FINAL CHANGE ORDER
City of Salinas
CHANGE ORDER 03

Date: 01/26/2024
Project: Natividad Creek Park Restroom Rehabilitation Project
Change Order #: 03

Owner: CITY OF SALINAS
Contractor: HA Construction

RESTROOM- Δ
ELEVATION AND MISC. DETAILS PLAN

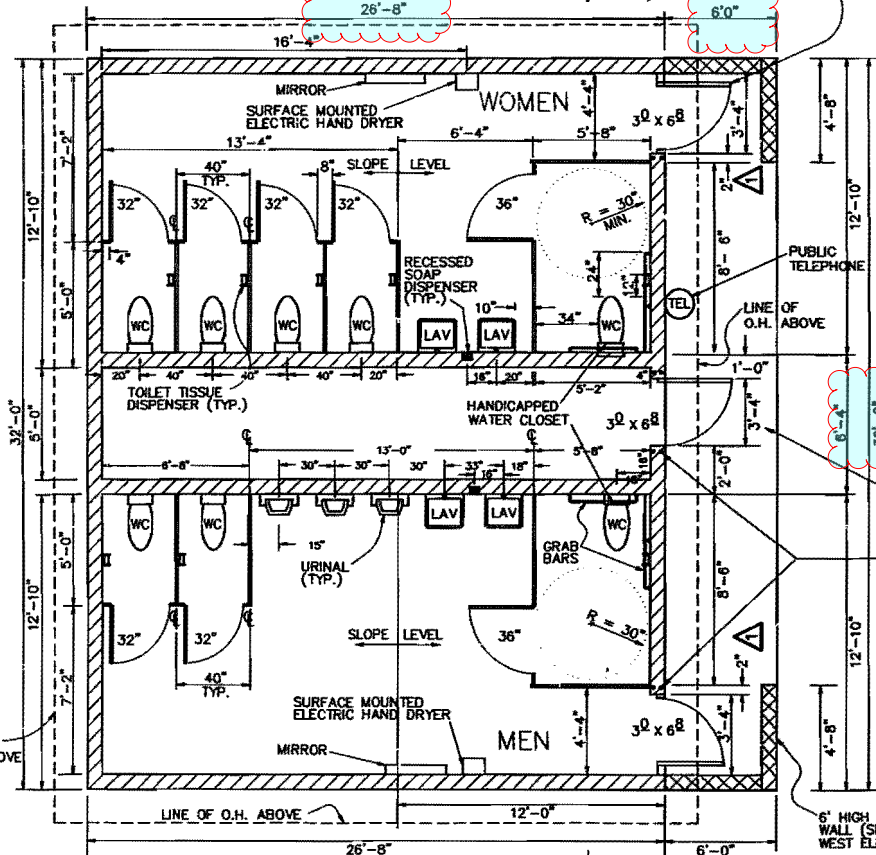
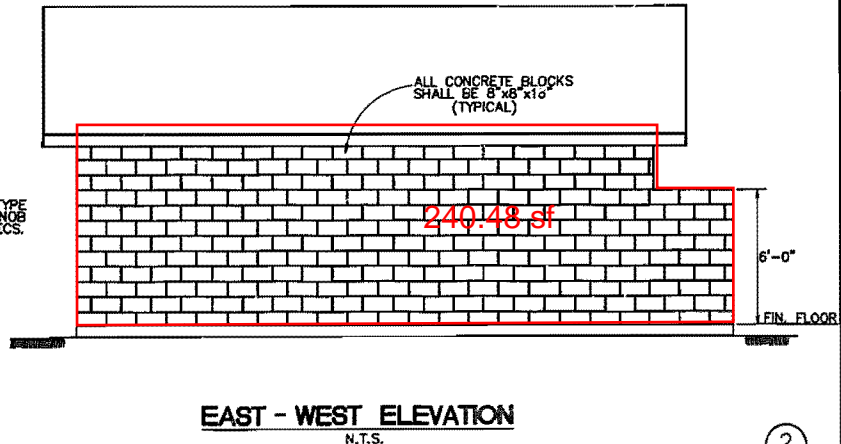
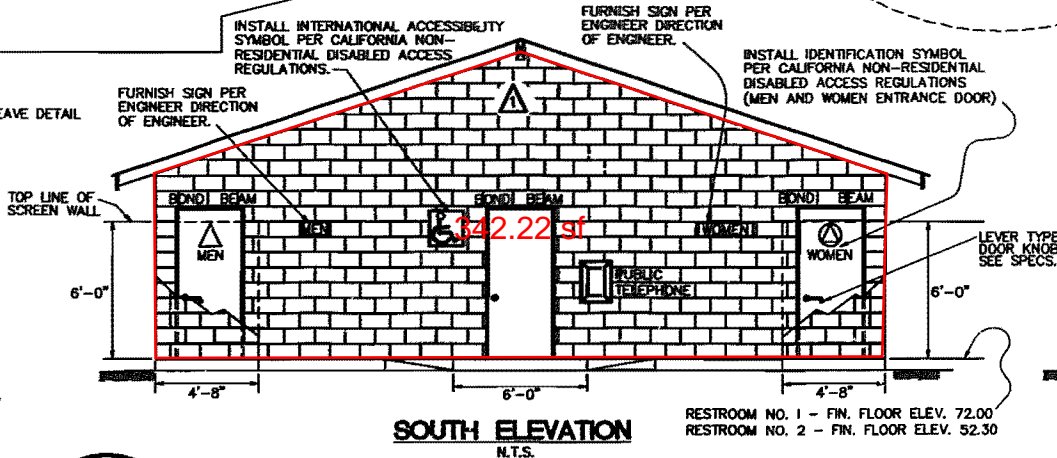
Ref. #	Summary Description:	Amount:
1	Per City's request to add Graffiti Coating on all interior and exterior walls, the Contractor submitted COR #6 requesting reimbursement for this work	\$8,467.61
Original Contract Amount:		\$151,000.00
Previous Change Order(s):		\$54,904.63
Contract Amount Prior to this Change Order:		\$205,904.63
Amount of this Change Order:		\$8,467.61
New Contract Amount Including this Change Order:		\$214,372.24
